Fix on next revision

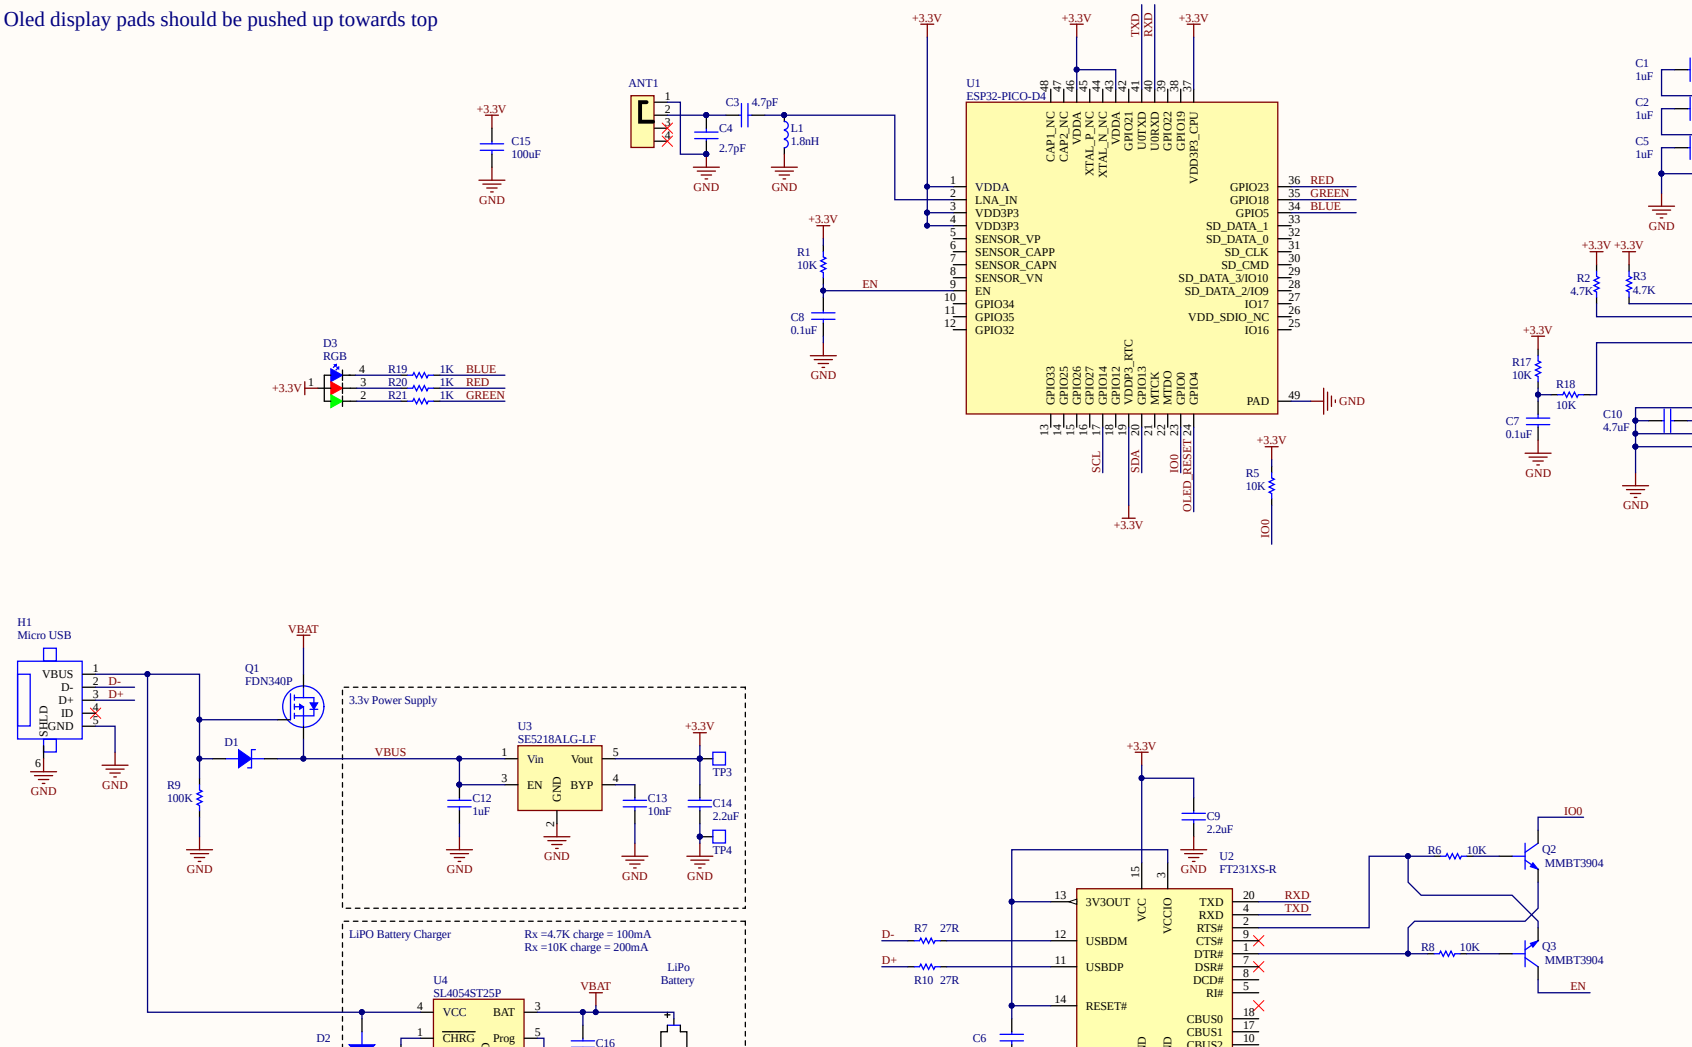
- RGB LED footpring wrong
- Oled display pads should be pushed up towards top
